# TOWN OF JACKSON

#### TRANSMITTAL MEMO

Item #: P18-135 &amp; 136

The applicant is submitting a request for a Hillside CUP for Physical Development on a parcel with slopes in excess of 10%. The property is located on 1255 W. Highway 22. In addition, the applicant seeks to amend their previously approved Development Agreement.

**Figure 1: Boussinesq Vertical Stress Distribution below Continuous Footing**

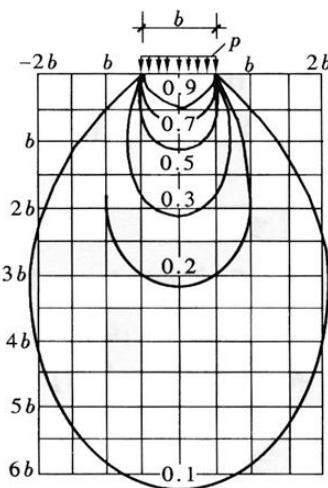
*Although assuming foundation pressures induced on underlying soil follow a linear distribution of 0.5H:1V, often referred to as the "2:1 Method", it is not the only approach to estimate pressures applied to soil by foundation elements. Boussinesq stress distributions, based on elasticity theory, have more of a "bulb" shape. The figure below shows the pressure distributions for a strip footing of width = b. As is shown in the figure, a pressure equipotential line equivalent to 30% of the foundation pressure (0.3p) extends to an approximate depth of 2b, commonly referred to as the foundation's "zone of influence", and only extends laterally to approximately 0.75b from the center of the footing. Therefore, in our opinion, requiring the excavation to extend the lateral distances suggested by LT is not necessary.*
